2013SYE099 – 15 The Avenue, Heathcote
DA14/0823

ASSESSMENT REPORT APPENDICES

John Paul Village – Development Application No DA14/0823
Response to ARAP Comments

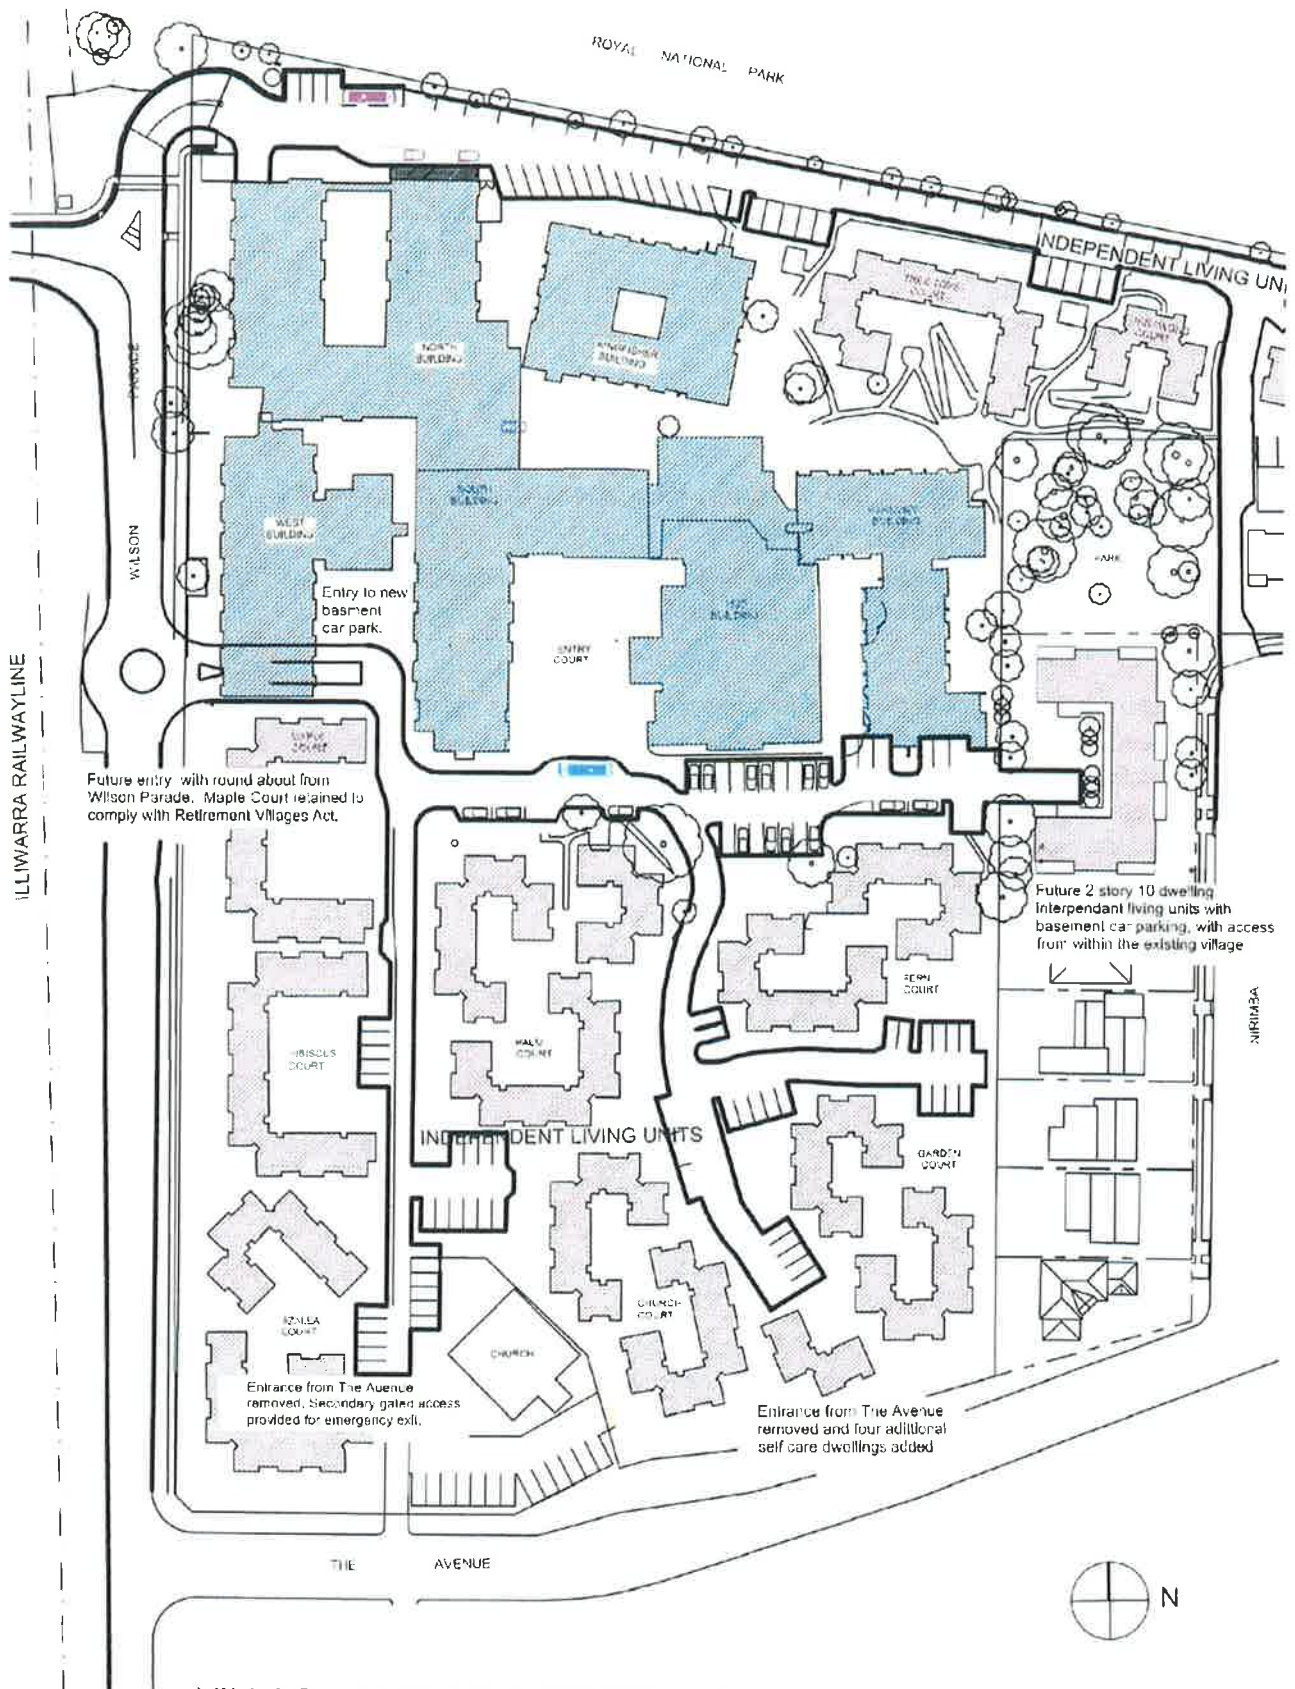
In response to the Panel's concern that an overall masterplan should be prepared to address a longer term vision for the entire Village, DEM has prepared a "15 Year Concept" that proposes that the main Village entry be relocated to Wilson Parade, and the existing two entries from The Avenue be deleted. The proposed entry will provide direct access to the new basement car park, the residential care main entry, and the Hub administration building. Additional short term visitor parking is proposed in front of the Hub building.

The concept would provide more separation between the Residential Care Facility and the self care dwellings. It would also reduce through traffic in the self care part of the Village providing a safer environment for residents, and reduce village traffic using the Avenue. The plan would also benefit local residents and reduce congestion due to school traffic by reducing Village traffic in The Avenue.

The master plan concept is seen as a longer term project and is provided for information and does not form part of the current Development Application. The Master plan will take time to implement as it requires the agreement of existing Village residents under the Retirement Villages Act, requiring the demolition of 6-10 self-care units.

Fig 2 Visitor parking

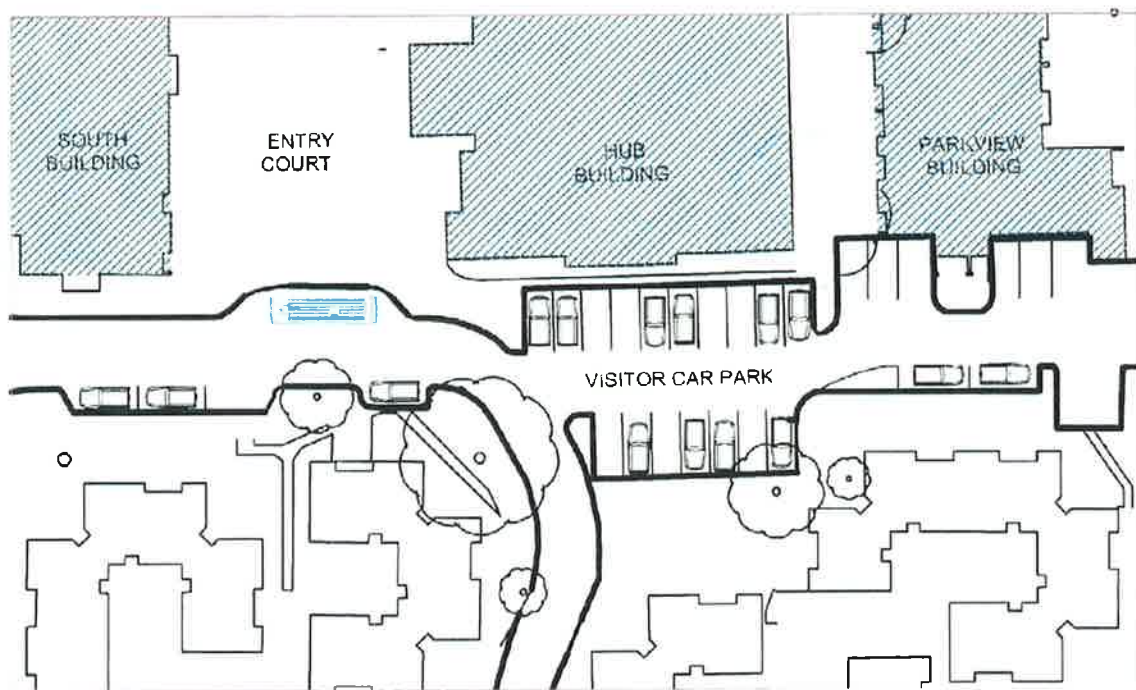
In response to the Panel's concern that visitors may be confused as to where to go, we have proposed to increase onsite parking in front of the Hub building, and opposite the entry court to the Residential Care Facility to 20 vehicle spaces as indicated in Figure 2. The number of ground level visitor spaces will be further increased by relocating some existing ground level self care parking to the new basement and using these spaces for visitors. These spaces will be designated as "visitor spaces only" and will be used for visitors who have not been inducted on the use of the basement car park.

To facilitate the use of the basement car park by resident's families they will be given an orientation pack that includes an access card to gain entry to the car park, as well as details of parking arrangement. The carpark will also be for staff and self care residents.

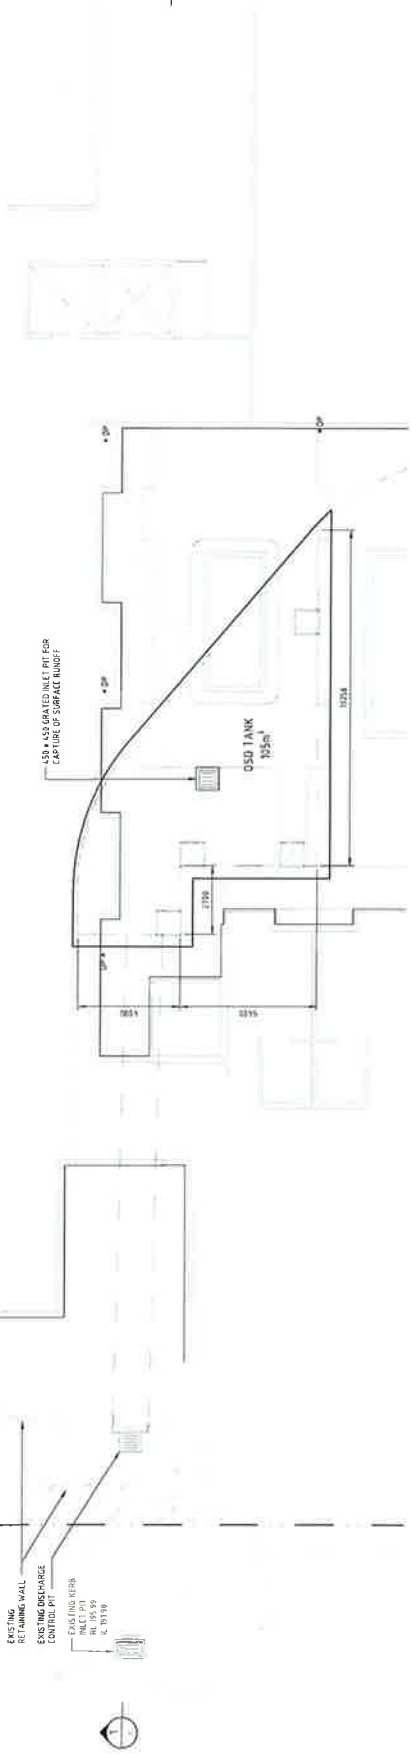
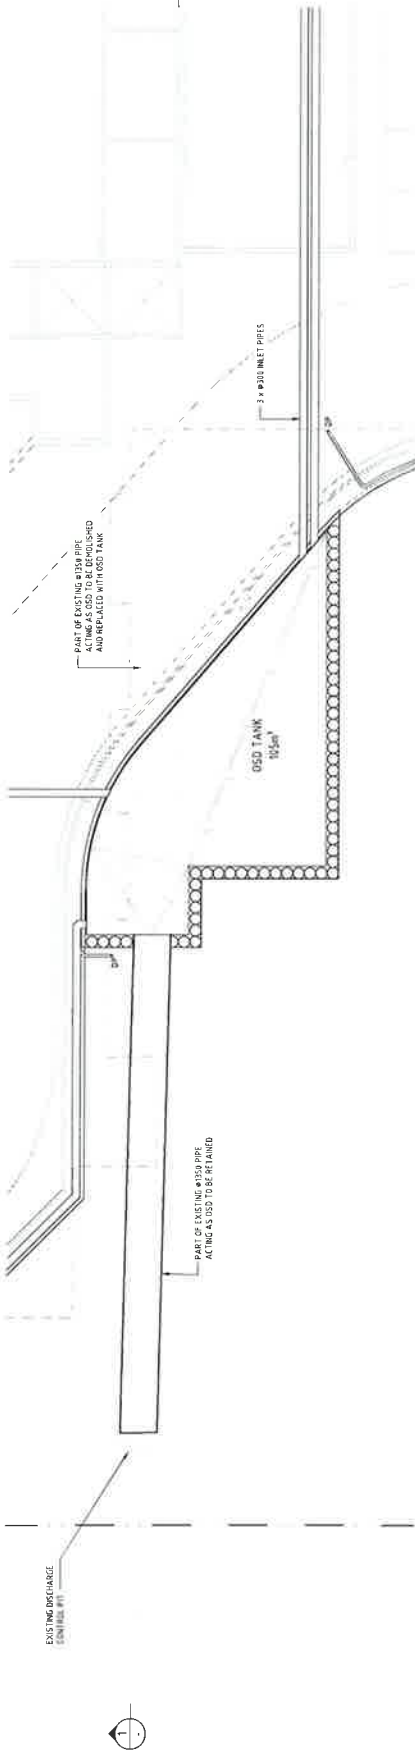
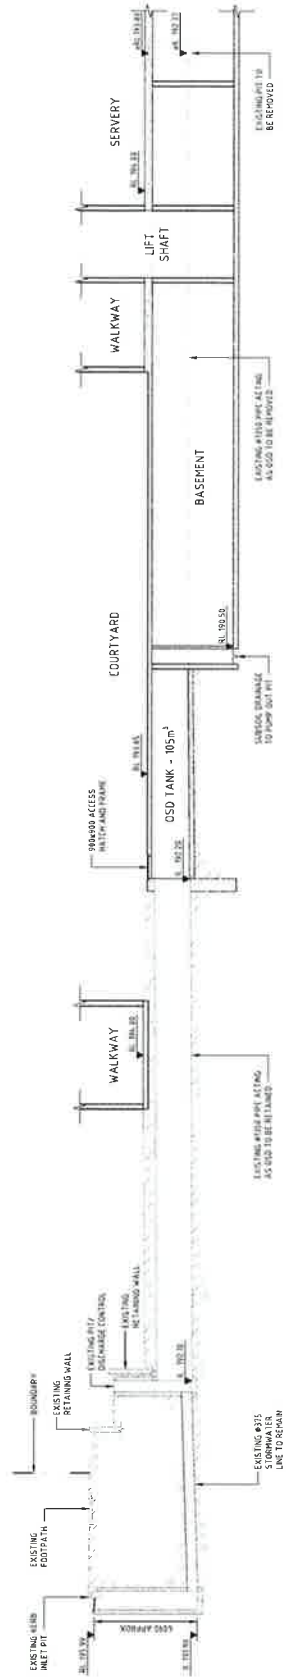
We confirm the proposed OSD tank ultimately drains to an existing kerb inlet on the eastern side of Wilson Pde. This pit is at the top of the line and has a grate level of RL195.99 and IL191.60. A DN375 RCP extends to the south from this pit.

Northrop drawings C4.11 and C4.21 have been updated to reflect this.
